South Texas Project  
Units 3 and 4  
Docket Nos. 52-012 and 52-013  
Revised Response to Request for Additional Information

RAI 09.01.02-9

Attachment: RAI 09.01.02-9 Response Revision 1

Summary: Provide additional information about the seismic loading for the nonlinear time history analysis of the spent fuel racks.

Figure 7: Original Acceleration Time History – X Direction (Horizontal)

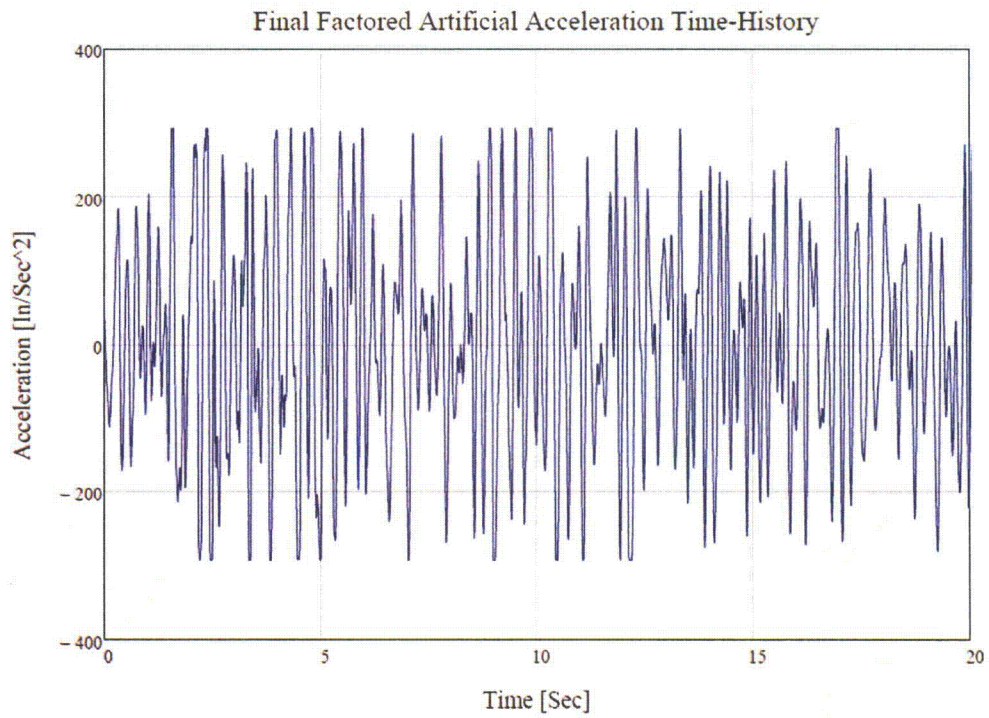
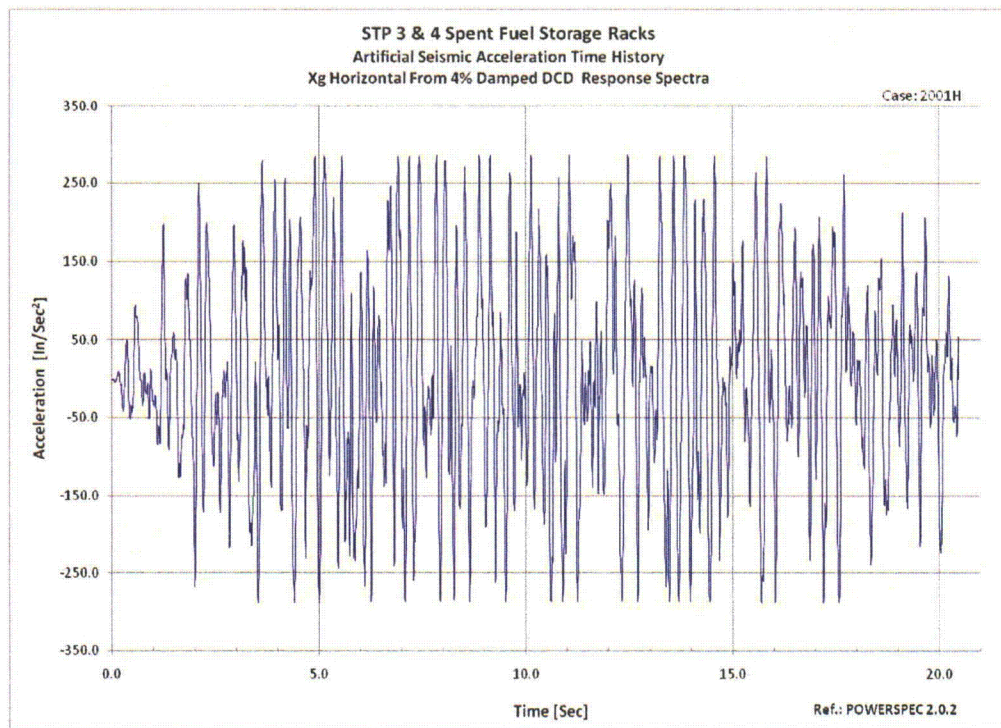
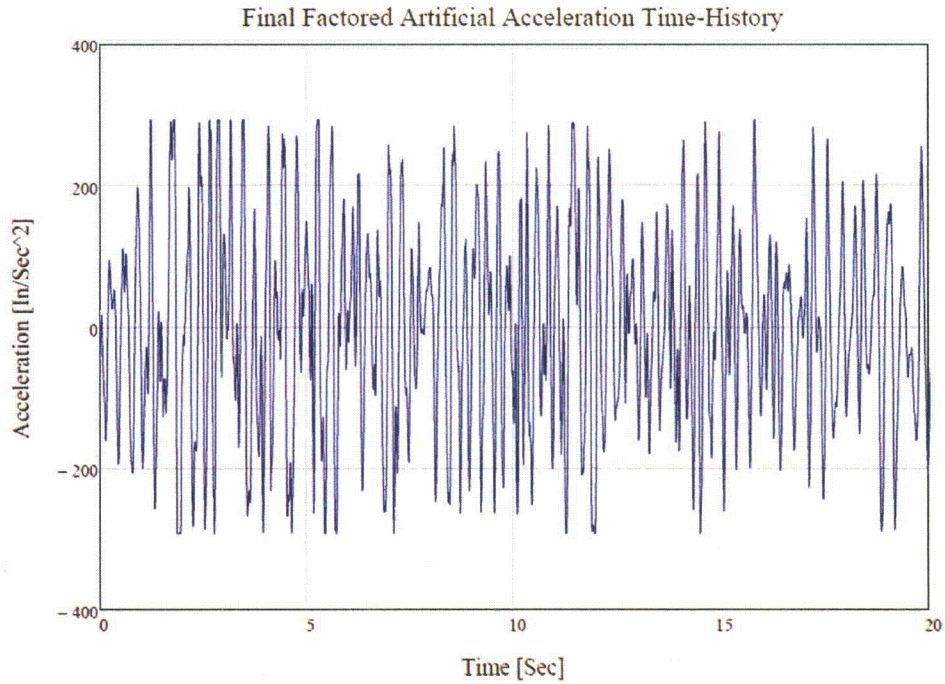
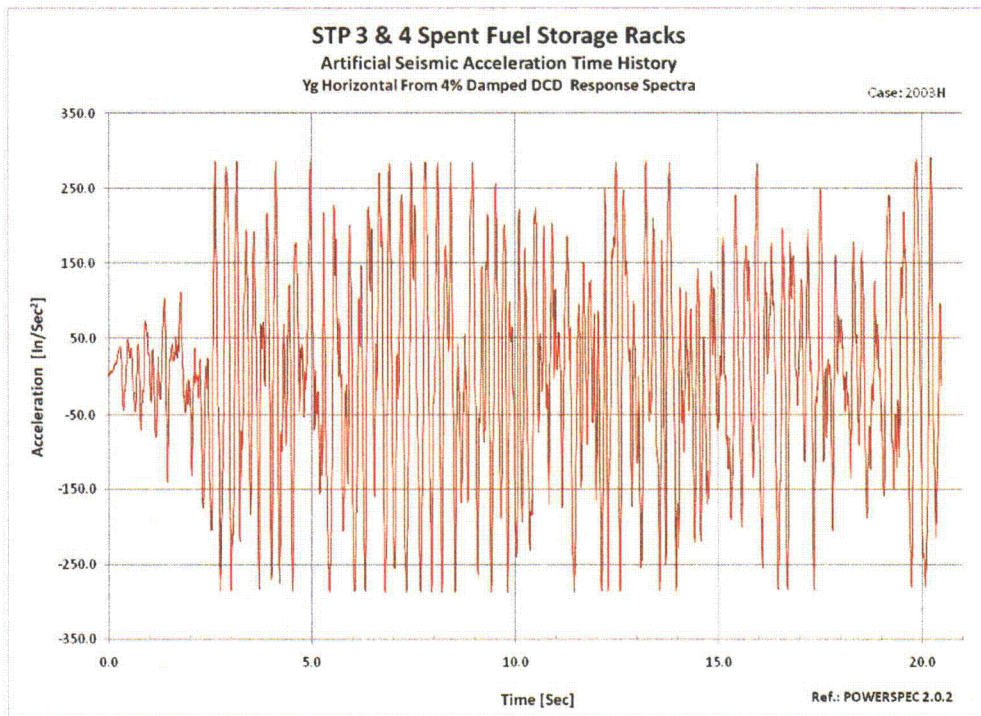
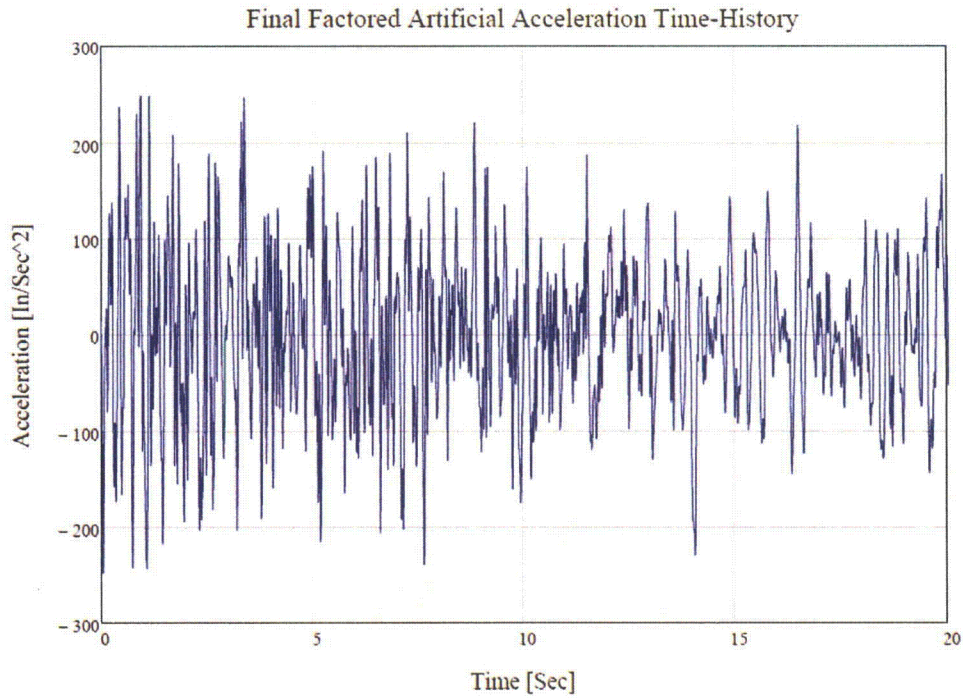
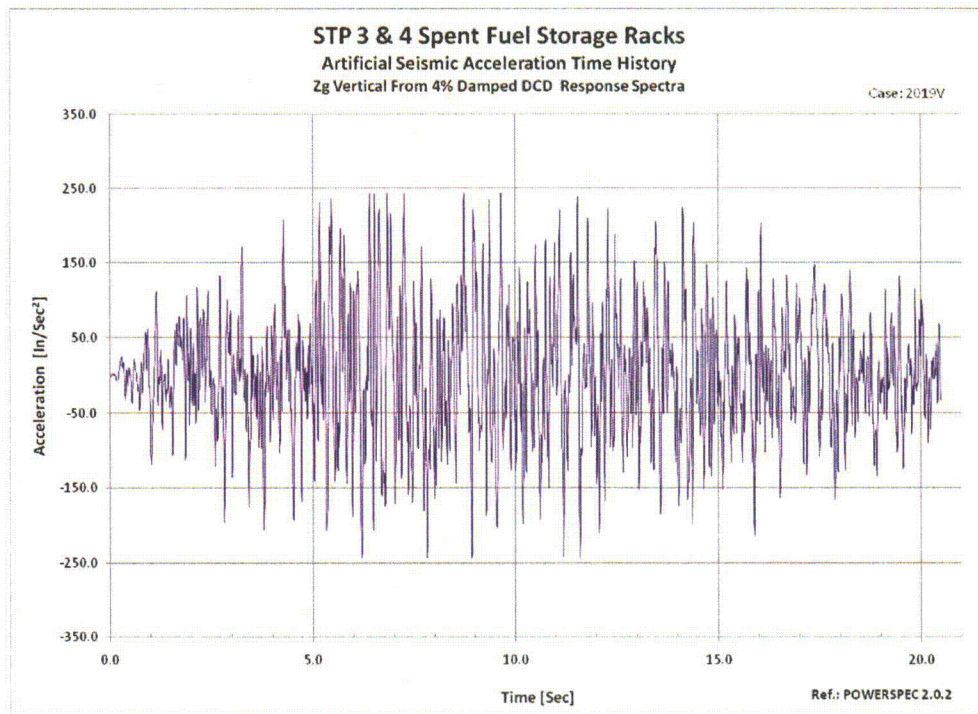
- d. The plots of the horizontal synthetic time histories presented in Figures 4-2 and 4-3 of the Technical Report exhibit the characteristic that there are many acceleration peaks up to the target spectrum ZPA. It appears that these time histories are derived from traces that had higher acceleration peaks, and all the higher peaks were reduced to the ZPA. Consequently, the synthetic time histories do not look like earthquake time traces. Please explain the process used to develop the horizontal synthetic time histories, and provide the technical basis for their adequacy.

The process used to generate the artificial time histories is the same process used by Westinghouse to generate artificial time histories for the AP1000 spent fuel rack licensing effort. This approach yielded results that meet the requirements of NUREG-0800, SRP 3.7.1 as described in the response to c. above. The methodology uses a MathCAD spreadsheet to perform an iterative calculation, which converts a starting recorded earthquake ground motion, in this case the El Centro earthquake, to a time history with a calculated response spectrum that closely matches the target input seismic response spectrum. If, during an iteration, the acceleration exceeds the specified Zero Period Acceleration (ZPA), the worksheet automatically lowers the value to the ZPA (also known as “clipping”). This is a standard part of the methodology, and results in synthetic time histories that closely match the target response spectra. The resulting time histories (design-basis time histories) are used in the design and analysis of the spent fuel racks.

As part of the response to the RAI, Westinghouse created a second set of artificial time histories, using an alternative method, for the sole purpose of confirming the adequacy of the original time histories used in the fuel rack analysis. The alternative method of producing artificial acceleration time histories is a mathematical approach of overlapping sine waves. This approach is available in PowerSpec 2.0.2 software. This software tool provides limited control of the ramp in and out of the strong motion portion of the event; however, there is less control over the matching of the calculated response spectrum (therefore, results may include overly conservative peaks in acceleration at any number of frequency points within the spectrum). A number of test cases were evaluated. These curves did have the classic appearance (i.e., ramp in and ramp out) and did not require “clipping” to maintain ZPA. Two successive integrations of the artificial acceleration time histories produce velocity and displacement time histories that did not exhibit “drift” and therefore does not require baseline or “drift” correction. This alternate method produced very similar results compared to the first (MathCAD) method. A comparison of acceleration time history results are included in Figures 7 through 12. For additional comparison, as further discussed in part f., a single rack model was run, with input generated from both the design-basis time histories and the second set of time histories. These results are also very similar, which confirms the adequacy of the design-basis time histories.

In summary, the design-basis time histories were created using the same methodology as that accepted for the AP1000 spent fuel rack seismic analysis, and they satisfy the acceptance criteria as provided in NUREG-0800, SRP 3.7.1. To confirm these original time histories, a second set of time histories was created using an alternative method. The second set of time histories closely matches the originals, and test runs using input from both time histories provide similar results. Therefore, the design-basis time histories are confirmed to be acceptable.

Figure 13: Baseline Corrected X Displacement

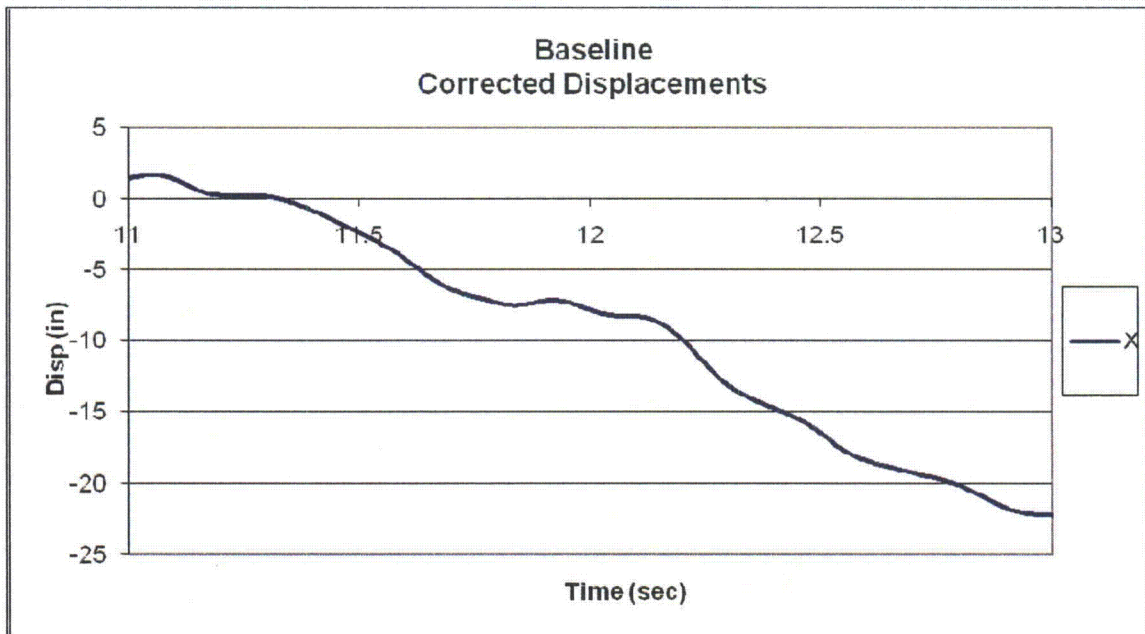
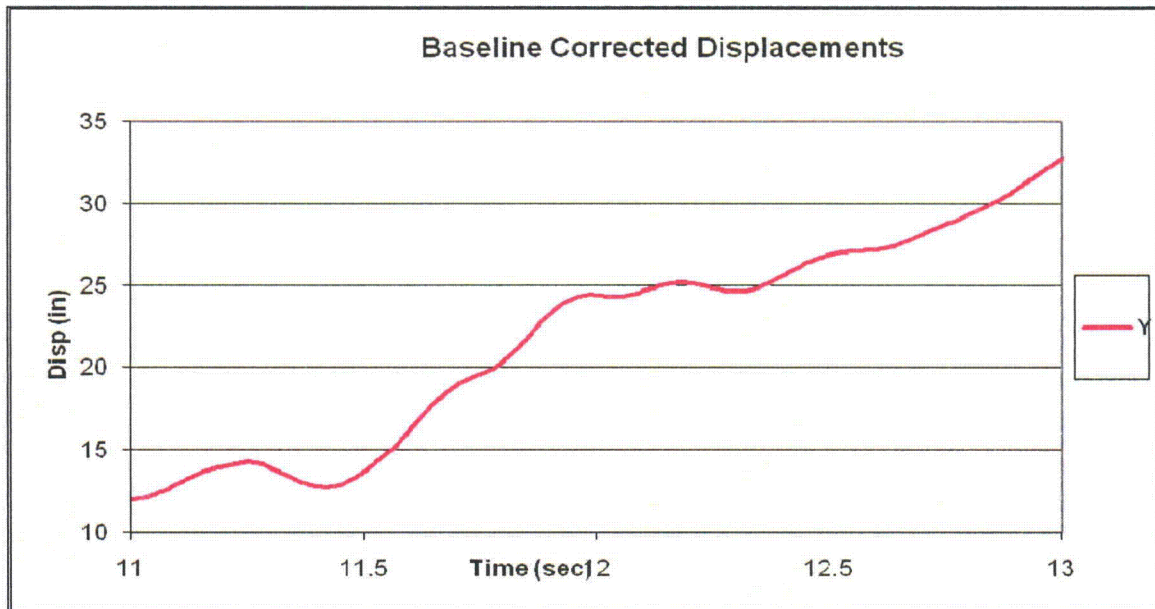
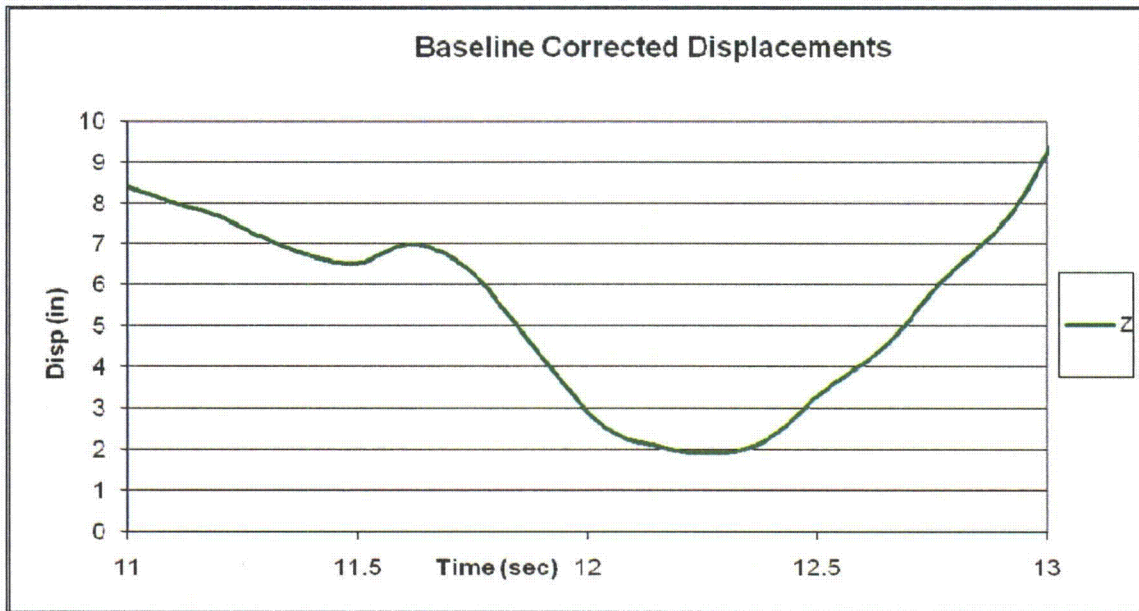
- f. The plots of the baseline corrected displacement time histories (x, y, z) presented in Figure 4-5 of the Technical Report exhibit several characteristics that require clarification and explanation: (1) All 3 displacement time histories exhibit a dominant sinusoidal response with a period which is same as the duration of the acceleration time history (2) All 3 displacements are zero at three specific time steps. (3) Although there is only 1 horizontal target spectrum, the peak x displacement is approximately  $\frac{1}{2}$  of the peak y displacement. (4) The 2 horizontal displacement histories are completely out-of-phase with each other; the vertical displacement history is perfectly in-phase with y and completely out-of-phase with x. Describe how the displacement time histories are developed from the synthetic acceleration time histories, and provide the technical basis for the adequacy of the generated displacement time histories.

The displacements are the double integration of baseline corrected acceleration time histories that satisfy statistical independence criteria. All fuel rack results reported are relative to the floor motion. Figures 13, 14, and 15 show the baseline corrected displacement time histories on a magnified time scale. These figures show that the high frequency displacements in each direction are not in phase and are not a constant ratio of each other. Figure 16 shows a portion of the X motion for the corrected acceleration time history and the corrected displacement time history, which is calculated by double integrating the corrected acceleration time history. The fuel racks dynamically respond to the higher frequency, smaller amplitude cyclic waves shown in these plots. Figure 17 shows Technical Report Figure 4-5 with the data point markers removed.
